ADDENDUM NO. 04

Northland Corridor Redevelopment Project Phase 4
631 Northland Ave.
Buffalo, NY 14211

Project No. 432607

Project Northland Corridor Redevelopment Phase 4 (BUDC) Addendum No. 4
631 Northland Avenue, Buffalo, NY Contract -
Wendel Project No. 432607 Date 10/31/25

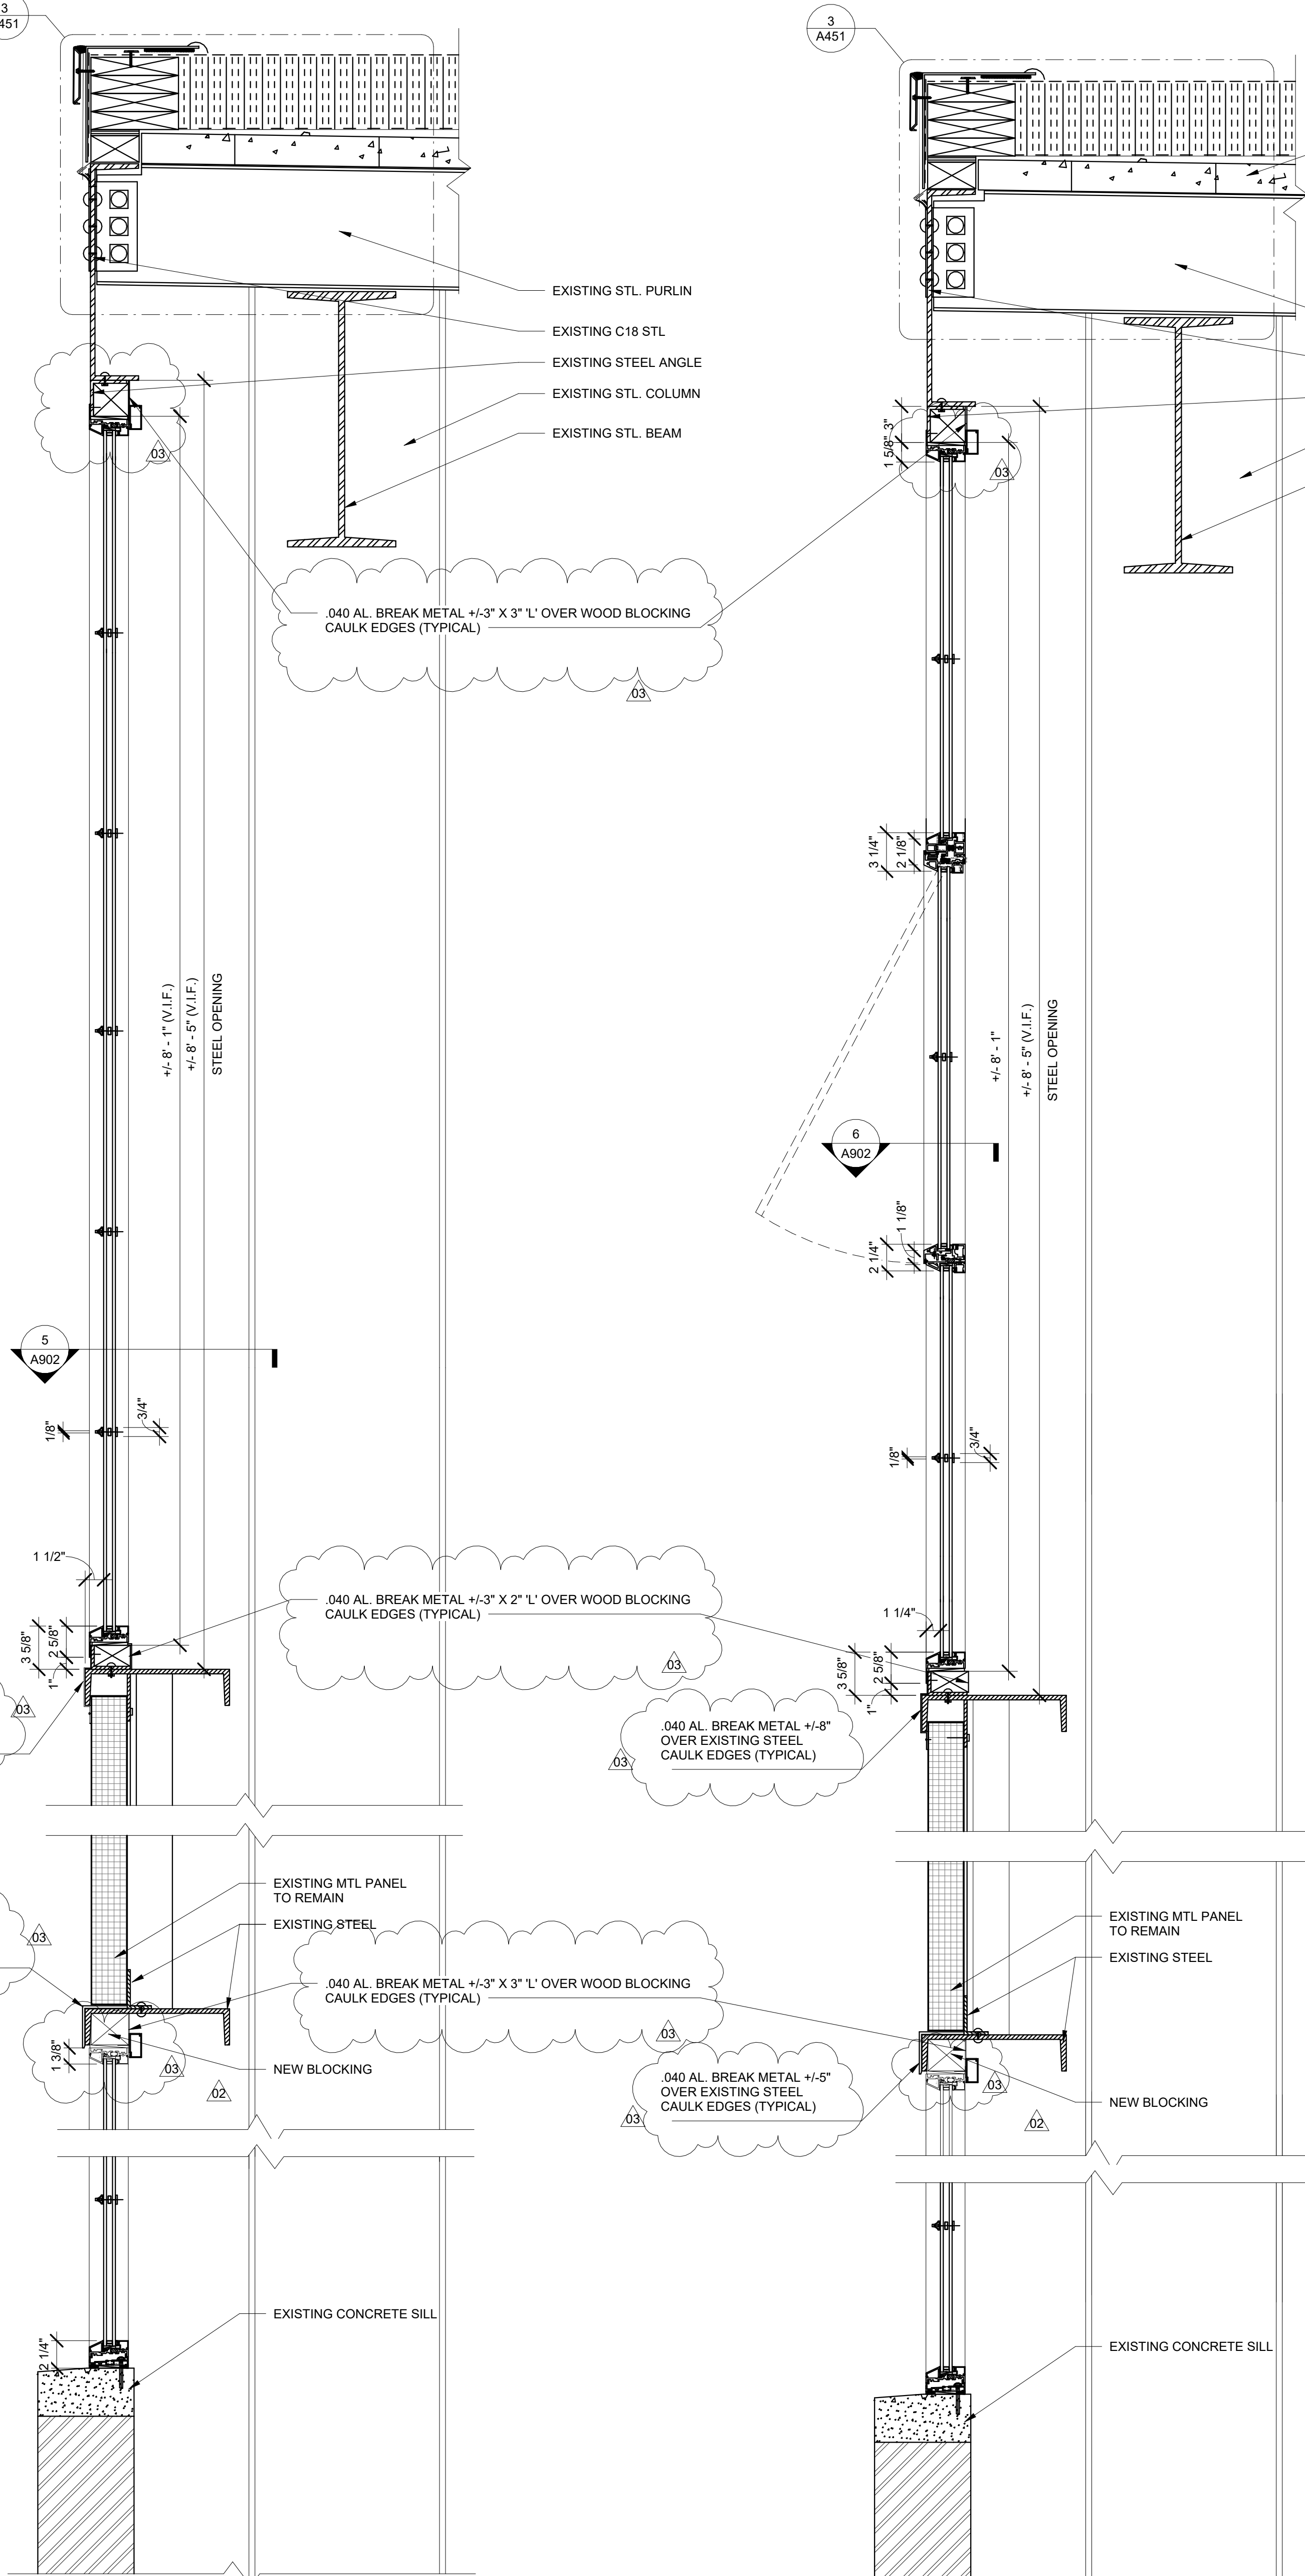
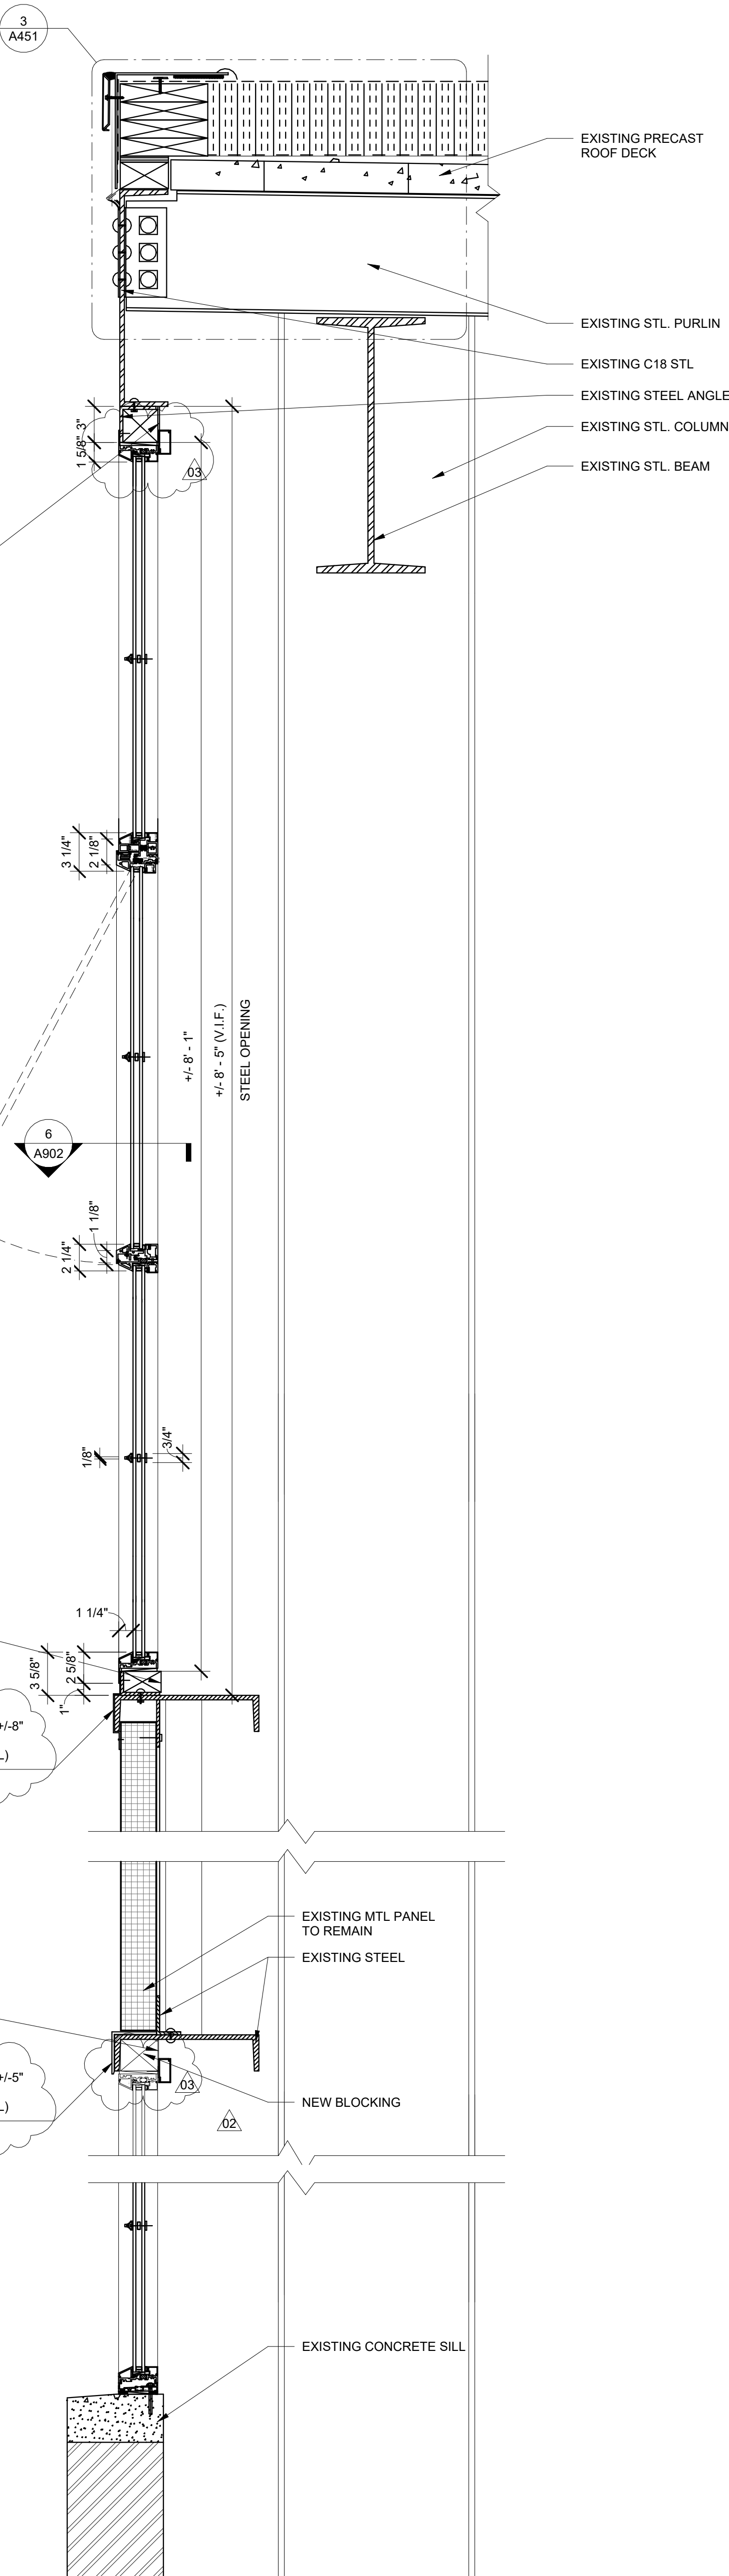
QUESTION: It appears that there are long runs with 3 pc mullions between each unit and a sill starter extrusion at the sill and interior snap trim and clip at the head, is that correct? Please clarify.

Section details 6 & 7 on A901 do not appear to show the 2nd floor window conditions for the head and sill. Is contractor to assume the head and sill shown in details 6 & 7 on A901 are the same as the 2nd floor windows?

Please reference A901: Detail 5/A901 just shows the window "floating" at the head. Is there to be wood blocking AND interior snap trim at this location?

Section 6 and 7/A901: Snap trim is detailed at the head of the first/lower section. Is this also to be at the second/middle section that is not shown? The upper section does not detail any snap trim, so I am unsure what the requirement is of the second/middle section.

Addendum #3 removed snap trim details 5, 6, 7 on A901. What should be used to capture the head the windows at detail 6 & 7. Would a head receptor be acceptable in these locations, or what is the intent here? Please confirm snap trim is still required per details 3 & 5 (sill location) on A901.

ANSWER: Please refer to revised drawing A901 attached for further clarity.

The head detail is the same on the 1st and 2nd rows of windows per the attached A901. The head detail on the 3rd row is shown and slightly different. The sill detail is the same on the 2nd and 3rd rows. The sill detail is different on the 1st row as shown.

There is break metal required. The wood blocking on the interior will receive .040 break metal. Approximate sizes have been clarified on the attached A901. The exterior will receive the same break metal to cover the existing steel. Photographs of the existing condition and selective demo are attached for reference. There is currently no flashing provided at the head of the 3rd row of windows. Note that Sections 6 & 7 on A901 only show the first and third rows of windows. The second row of windows has the same details and requires the same break metal flashing and blocking.

CLARIFICATION: Snap trim IS REQUIRED and clarified as such on the revised A901. Please disregard Article 5 in Addendum 03 which removed the snap trim.

REPLACE: Drawing A901 with the revised attached to this addendum.
